## Fingerboards Mineral Sands Project Inquiry and Advisory Committee Technical note

**TN No:** TN 031

**Subject:** Response to the IAC's third request for information (10 May 2021, Tabled Document 294), questions 2-5 relating to dam construction

*Figure 14 - 3d View of WSD from the East*

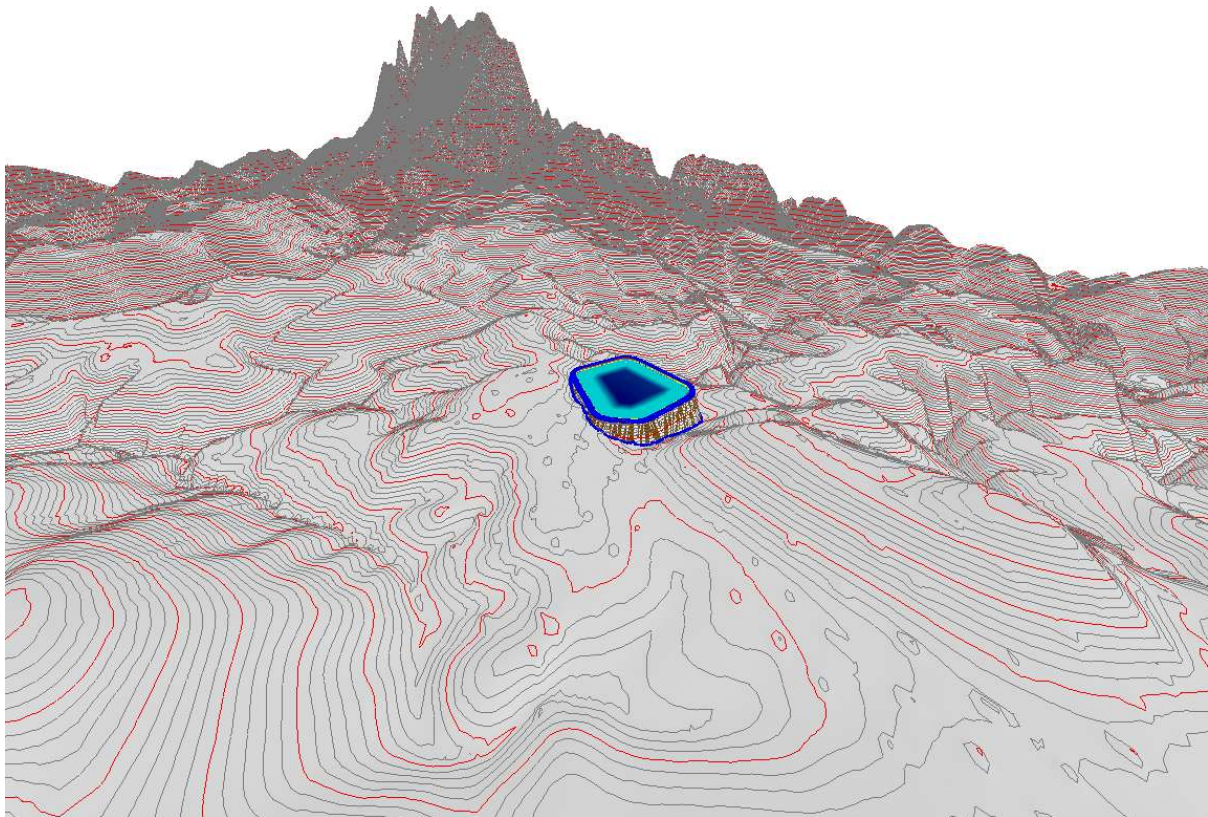
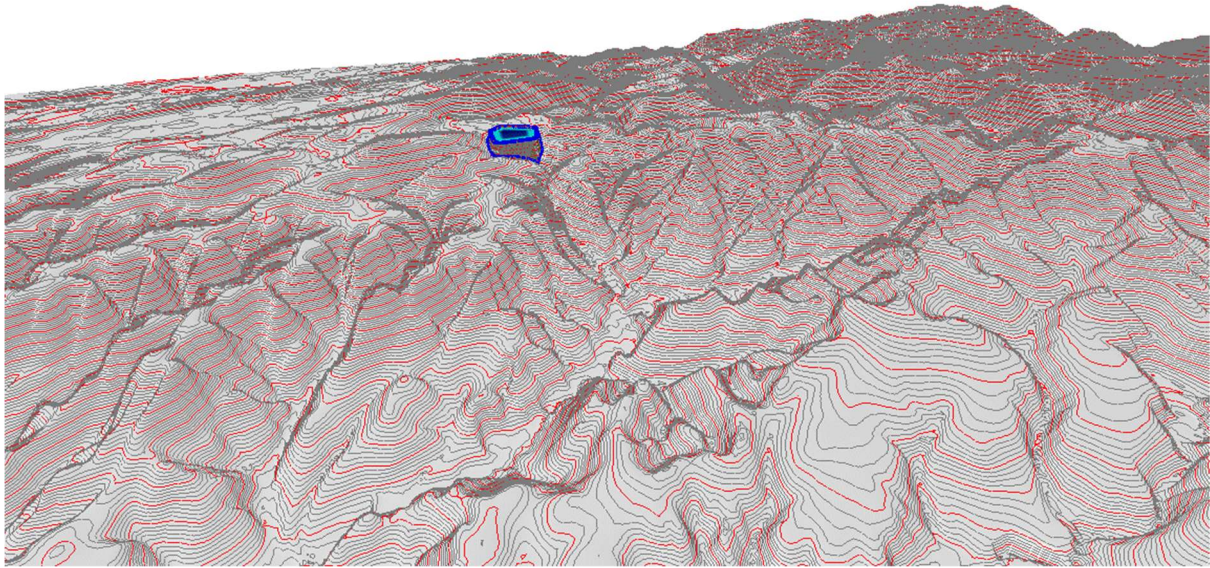
5. Whilst it may be a low likelihood, to what extent has Project risk planning considered the consequence of a catastrophic dam wall failure?

Preliminary 2-D modelling has been undertaken for the water storage dam as part of an analysis of the consequences of the failure of the Tailings Storage Facility (**TSF**). This modelling indicates that during a catastrophic dam failure, water would discharge initially to the north and then east, crossing the Bairnsdale-Dargo Road and Fernbank-Glenaladale Road, before discharging into the Mitchell River. Modelling of other water dams across the site would be undertaken to inform the detailed design of the dams. The relevant part of the TSF dam break analysis is attached, noting that Kalbar no longer intends to construct the TSF.

The water storage dam (WSD) is located near the crest of the plateau and is surrounded by deep incised valleys as illustrated in **Figure 14** and **Figure 15** has been designed as a cut to fill, side valley dam, with crest embankment level of 125 mRL, with a storage capacity of 2.2 Mm<sup>3</sup>, of which 0.6 Mm<sup>3</sup> is located below the lowest point on the internal natural ground surface at 108 mRL, allowing for only 1.6 Mm<sup>3</sup> of water to be potentially realised from storage during a dam break scenario with up to 0.6 Mm<sup>3</sup> of embankment material. As the intent of the dam is a water storage dam, a spillway is not included within the design, with water levels in the dam controlled by pumping to the dam, with adequate operational allowance for incipient rainfall storage from a storm event up to an including the PMP. Thus whilst unlikely during operation, failure due to overtopping is modelled in this dambreak scenario. The maximum height of the dam is 22.5m relative to the downstream toe of the embankment, and 17m relative to the natural surface under the embankment.
